ADA Curb Ramp New Construction Inspection Form (Parallel)

NW Main

23885.56

NW Lenox

PARALLEL RAMP (PL)

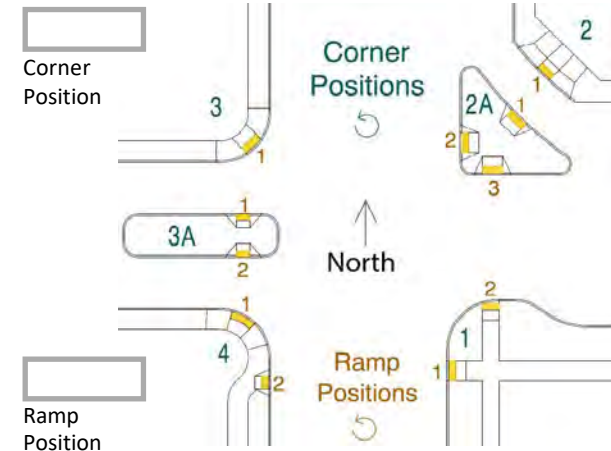
☐ 9.7 $\leq 8.3\%$ ☐ $> 8.3\%$ ☒

Comments:
DWS IITD Fails Turn and RR 1, ICRR 2
